UNITED STATES
NUCLEAR REGULATORY COMMISSION
OFFICE OF INSPECTION AND ENFORCEMENT
WASHINGTON, D.C. 20555

IE Bulletin No. 80-20

FAILURES OF WESTINGHOUSE TYPE W-2 SPRING RETURN TO NEUTRAL CONTROL SWITCHES

FIGURE 1

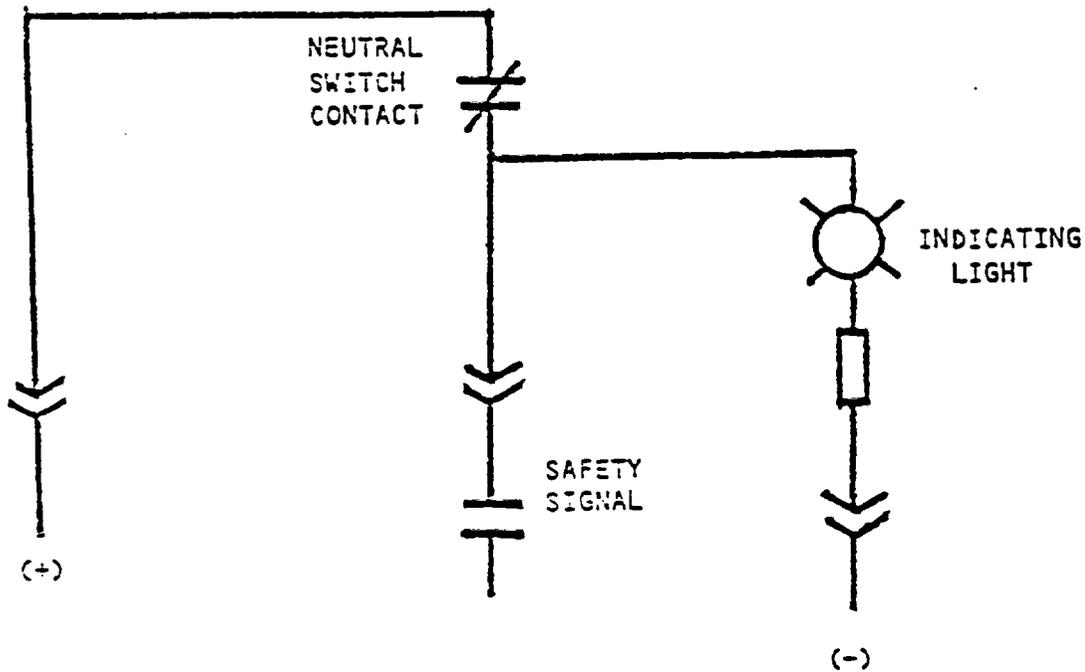
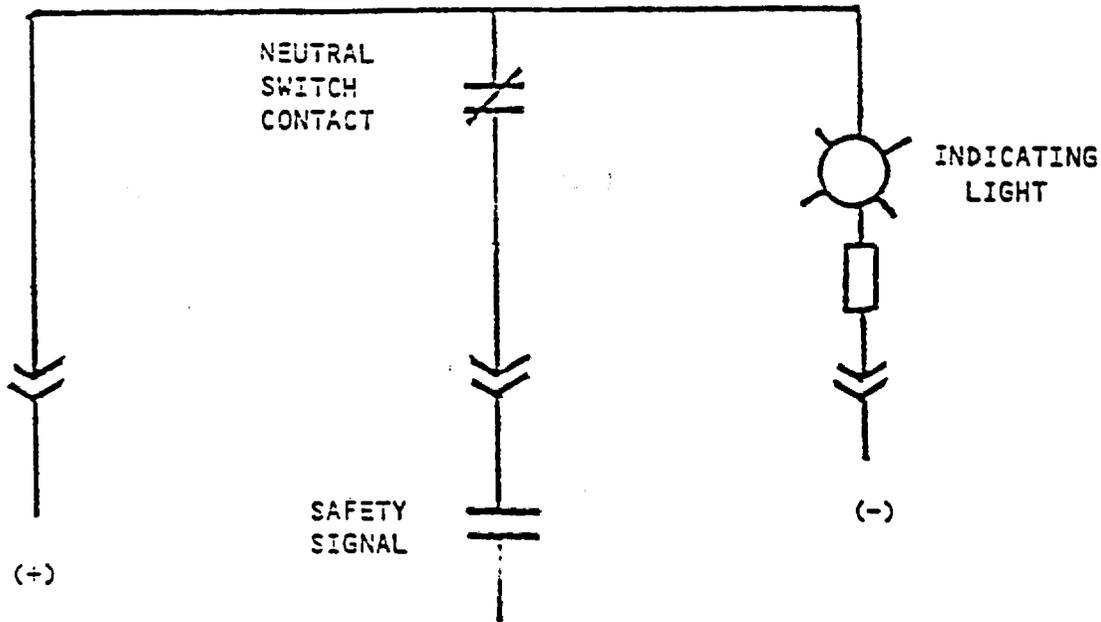
A review of this matter by Westinghouse led to the issuance of NSD Technical Bulletin No. NSD-TB-80-9 to the utility owners of all Westinghouse operating plants. The recommendations contained in the Westinghouse technical bulletin include: (i) testing the neutral position contacts of the subject W-2 switches for continuity, and (ii) rewiring of the indicating light circuit to permit the early detection of a neutral contact failure as shown in Figure 1.

Depending on how the indicating light circuit is wired, loss of continuity thru the neutral position contact of a W-2 switch could remain undetected until the equipment associated with the switch were called upon to operate. Since such a failure would be equivalent to by-passing the system associated with the switch, consideration should be given to rewiring the switches used in safety-related applications as shown in Figure 1. Such rewiring would provide an acceptable means for detecting contact failure, provided the indicating light is in the control room and readily visible by the operator. If the indicating light is not so located, consideration should be given to annunciating the neutral position contact failures at the control room to alert the operator of the inoperable status of a safety-related system. In addition, consideration should be given to adding redundant contacts to the W-2 switches or to replacing the W-2 switches with others having a more positive contact wiping action.

3. Licensees of operating plants and holders of construction permits shall describe the longer term corrective measures planned and the date by which such measures will be implemented by actual installation or by design change, as appropriate. As a minimum, the longer term corrective measures should include rewiring the indicating light as shown in Figure 1 provided the light is readily visible to the control room operator. If not, failures of the neutral position contacts should be annunciated in the control room.

REWIRING OF INDICATING LIGHT CIRCUIT OF W-2 SWITCHES
AS RECOMMENDED BY WESTINGHOUSE TECHNICAL BULLETIN NSD-TB-80-9
